REMARKS

AMENDMENTS TO THE DRAWINGS

Fig. 2

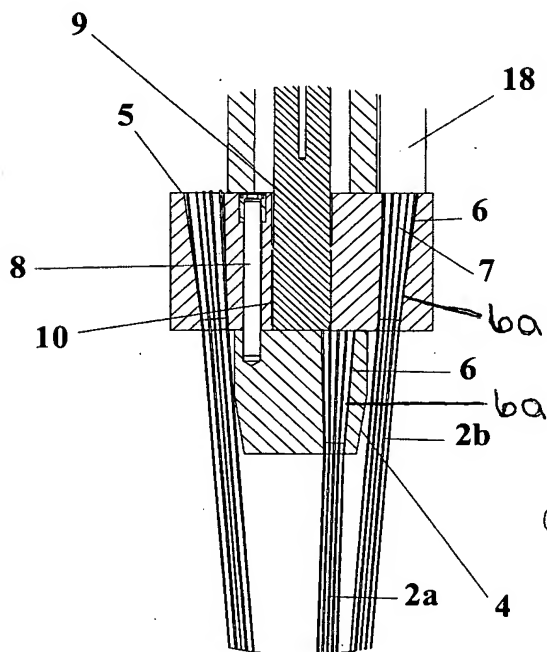
Office further objected to the drawings for failing to show a "slip agent", noting that structural details essential to understanding the invention should be shown, per MPEP §608.02(d).

Applicant responds that the specification and drawing Fig. 2 have been amended to add the reference "6a" for the term "slip agent", with an indication in Fig. 2 of its location on the wall of each hole 6. No new matter is added. These amendments should cure this objection.

Fig. 1

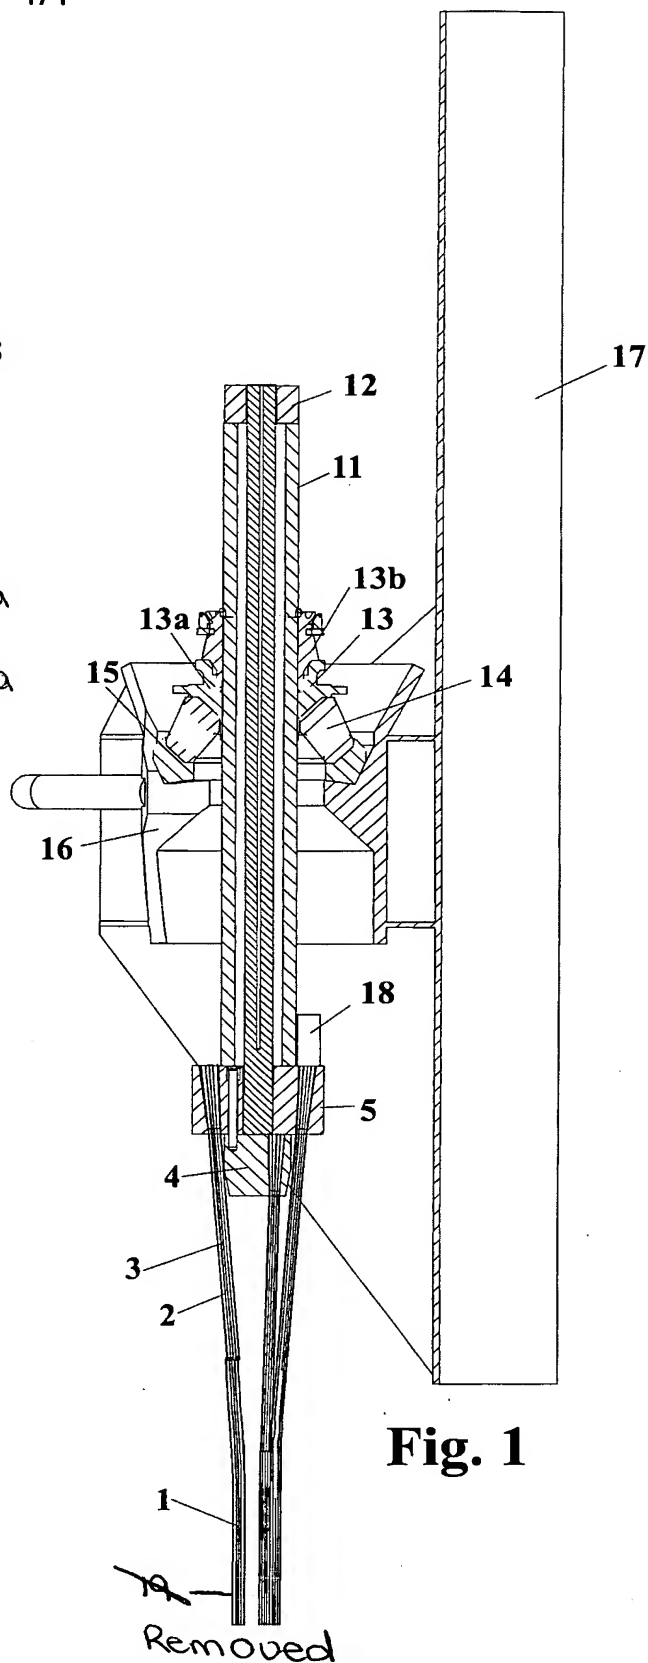
The Office objected to the drawings for a reference number 19 not cited in the specification. Applicant has herein amended the drawing to remove the offending number, which should cure this objection.

The attached "replacement sheet" and "annotated sheet showing changes" of drawings includes changes to Figs. 1 and 2. The replacement sheet, which includes Figs. 1-2, replaces the original sheet including Figs. 1-2. In Fig. 1, reference "19" has been removed. In Fig. 2, previously omitted element reference "6a" has been added.
